Board of Adjustment Hearing Application - Entry #359

16664 KEHRSGROVE DRIVE
CHESTERFIELD, MO
63005
US

This application is for a variance to permit the installation of a fence within the required yard setback area at 16664 Kehrsgrove Drive, Chesterfield, MO 63005. The property is a through lot with double frontage, which causes both the front and rear portions of the property to be treated as front yard areas under the City's requirements. Due to the unique lot, it limits the area significantly for a residential fence to be located around a pool.

Re: Building Permit Application - 16664 Kehrsgrrove Dr.

SITE PLAN

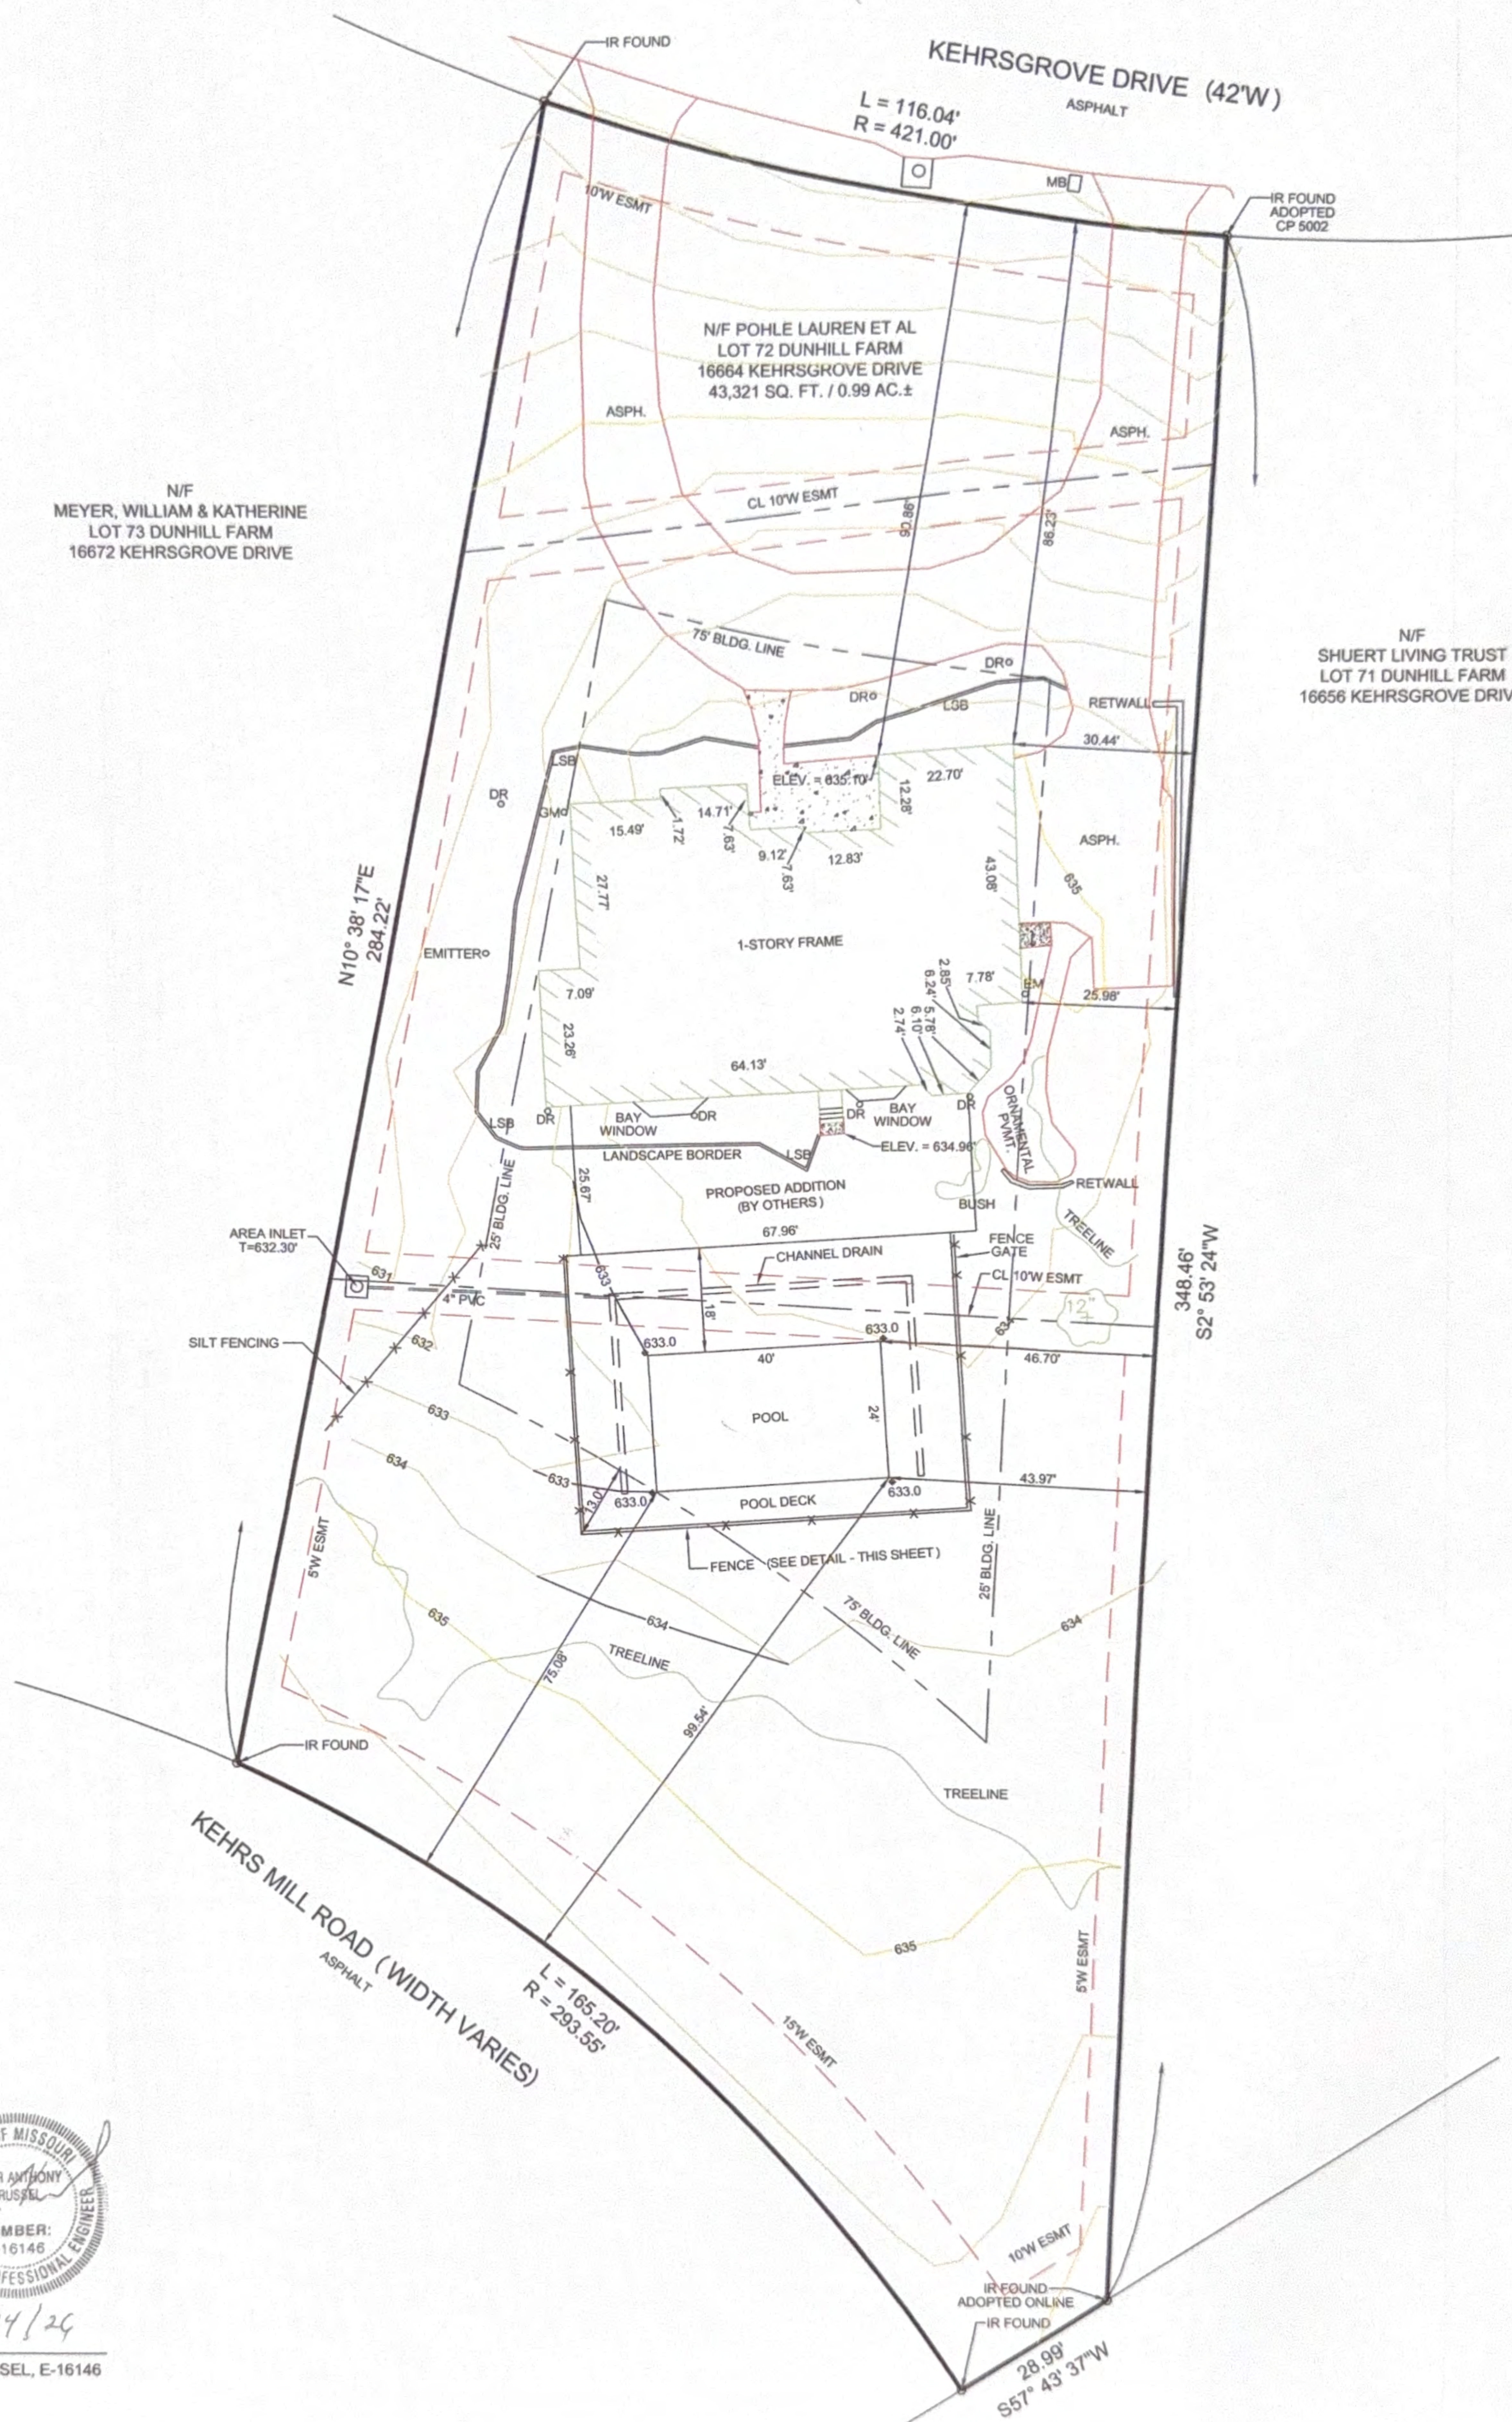
I did some research and it appears the site survey is correct. The lot is identified as a "Through Lot/Double Frontage" see the definition below.

Please note the fence in within the 75' building setback line and will require a variance approval before a permit can be issued for the pool project.

Contact Clarkson Valley staff to assist with the Board of Adjustment application process if this is the desired location of the fence.
